UNITED STATES  
NUCLEAR REGULATORY COMMISSION  
WASHINGTON, D.C. 20555-0001

SUBJECT: OCONEE NUCLEAR STATION, UNITS 1, 2, AND 3 - STAFF ASSESSMENT OF INFORMATION PROVIDED PURSUANT TO TITLE 10 OF THE *CODE OF FEDERAL REGULATIONS* PART 50, SECTION 50.54(f), SEISMIC HAZARD REEVALUATIONS FOR RECOMMENDATION 2.1 OF THE NEAR-TERM TASK FORCE REVIEW OF INSIGHTS FROM THE FUKUSHIMA DAI-ICHI ACCIDENT (TAC NOS. MF3736, MF3737, AND MF3738)

STAFF ASSESSMENT BY THE OFFICE OF NUCLEAR REACTOR REGULATION

OCONEE NUCLEAR STATION, UNIT NOS. 1, 2, AND 3

**Figure 3.2-1 Plot Comparing the Staff's and the Licensee's Mean Control Point Hazard Curves at a Variety of Frequencies for the Oconee Site. RAI Response Curves are Licensee Curves Developed using the Currently Endorsed CEUS-SSC (NUREG-2115) for the Oconee Site**

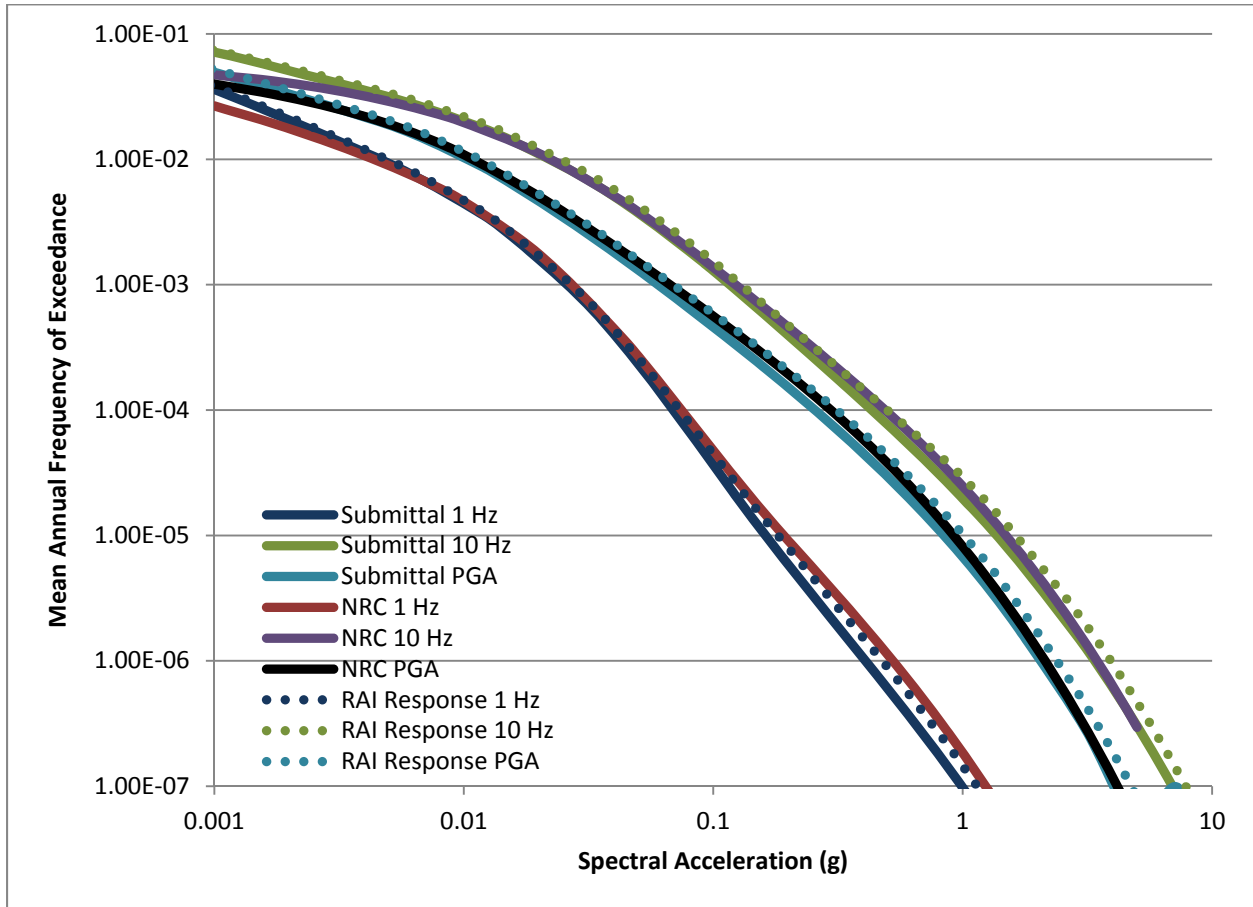
As part of its RAI response, the licensee provided base rock hazard curves in order to show the impact of its refinements to the CEUS-SSC seismicity catalog. Figure 3.2-1 of this assessment shows the licensee's base rock hazard curves along the staff's base rock hazard curves. As shown in Figure 3.2-1 of this assessment, the impact of the licensee's changes to the hazard inputs have a very minor impact on the hazard for the Oconee site.

Figure 3.3-1 Plot of Staff's and Licensee's Base Case Shear-Wave Velocity Profiles for the Oconee site

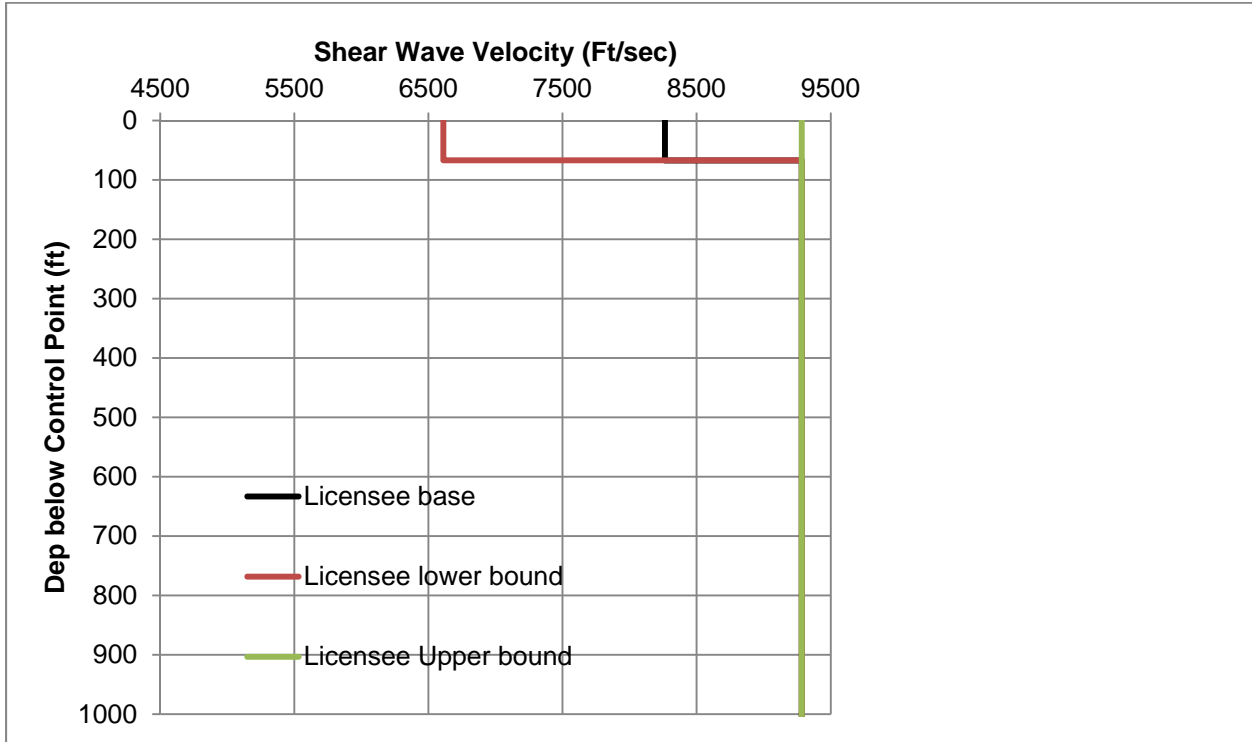
To characterize the subsurface geology, the licensee developed three site base case profiles. The licensee's middle, or best estimate profile was developed using measured the shear-wave velocity of 8,265 fps [2,519 m/sec] from the MSIV project and assumed to be constant over the 67 ft [20.4 m] of firm rock. The licensee developed upper and lower base case profiles using a natural log standard deviation of 0.20. As such, the lower velocity profile has a constant S-wave velocity of 6,612 fps [2,015 m/sec] and since the S-wave velocity for the upper velocity profile exceeds the assumed base rock velocity of 9,285 fps [2,830 m/sec], the licensee concluded that the upper profile should be considered as hard base rock. Figure 3.3-1 of this assessment shows the licensee's three shear-wave velocity base case profiles.

The licensee used the latest geotechnical exploration data to establish the shear wave velocity profile for the site, which was based on three boreholes with shear wave velocity measurements (P-S logging) at the distance between 19.5 and 28 ft [5.9 to 8.5 m] to the edge of the three reactor units. Because the site profile established based on some recent obtained and site-specific data and is fairly well characterized, the NRC staff used the same input velocity profiles as those provided by the licensee. Figure 3.3-1 of this staff assessment shows the velocity profiles used by the licensee and the staff.

Figure 3.3- 2 Plot Comparing the Staff's and the License's Median Amplification Functions and Uncertainties for two input loading levels for the Oconee site

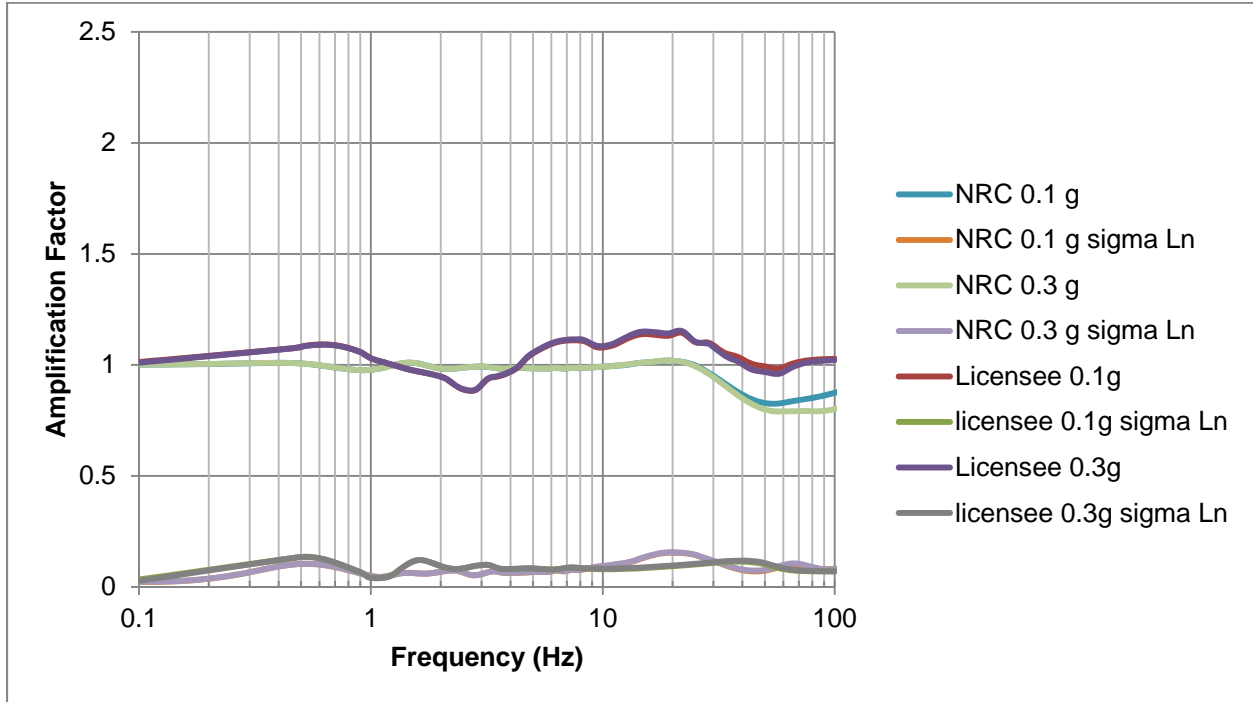
Figure 3.3-2 of this assessment shows a comparison of the staff's and licensee's median site amplification functions and uncertainties ( $\pm 1$  standard deviation) for 2 of the 11 input loading

levels. Due to the use of very low damping values and modeling of the rock behavior as essentially linear for the range of input loading levels, the NRC staff's confirmatory amplification factors are essentially one for the entire frequency range. The licensee's amplification functions are also flat over the entire frequency range for the two loading levels shown in the SHSR.

Figure 3.3-3 Plot Comparing the Staff's and the Licensee's Mean Control Point Hazard Curves at a Variety of Frequencies for the Oconee site

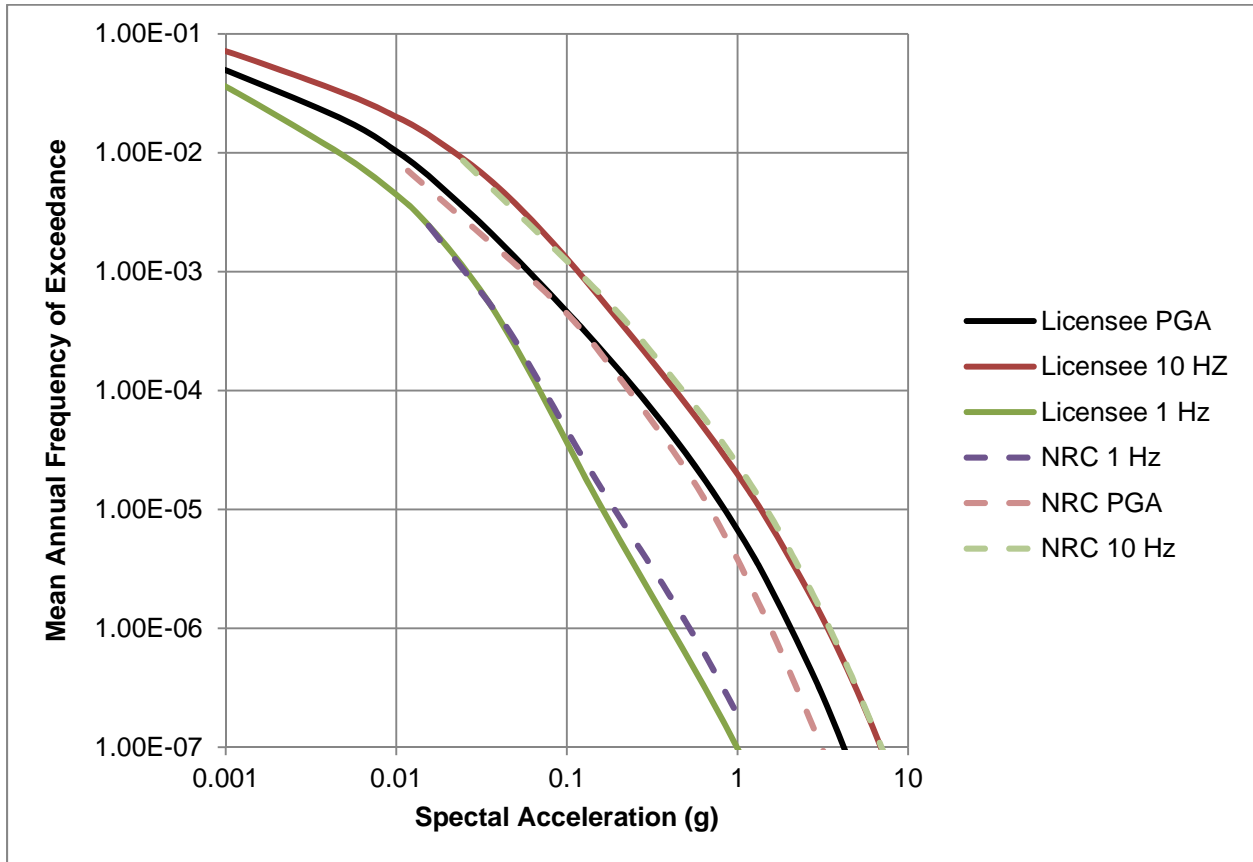
Overall, the licensee's approach to modeling the subsurface rock properties and their uncertainty, results in very similar amplification factors as those developed by the staff. In addition, as shown in Figure 3.3-3 of this assessment, the NRC staff's and licensee's control point seismic hazard curves are very similar.

Figure 3.4-1 Comparison of the Staff's GMRS with Licensee's GMRS and the SSE for the Oconee site

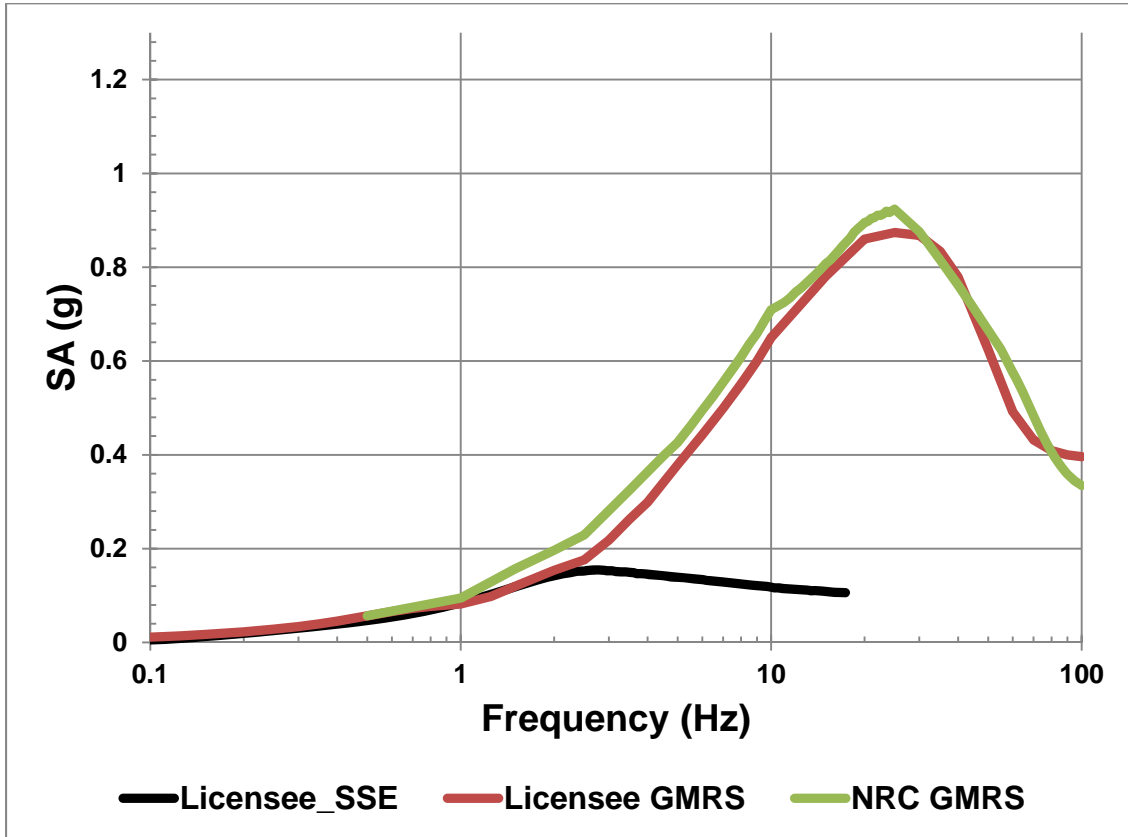
The NRC staff independently calculated the  $10^{-4}$  and  $10^{-5}$  UHRS using the results of its confirmatory PSHA and site response analyses, as described in Sections 3.2 and 3.3 of this staff assessment, respectively. Figure 3.4-1 of this assessment shows a comparison of the GMRS determined by the licensee to that determined by the NRC staff.

The NRC staff confirms that the licensee used the present-day guidance and methodology outlined in RG 1.208 and the SPID to calculate the horizontal GMRS, as requested in the 50.54(f) letter. The NRC staff performed both a PSHA and site response confirmatory analysis and achieved results consistent with the licensee's horizontal GMRS. As such, the NRC staff concludes that the GMRS determined by the licensee adequately characterizes the reevaluated hazard for the Oconee site. Therefore, this GMRS is suitable for use in subsequent evaluations and confirmations, as needed, for the response to the 50.54(f) letter.
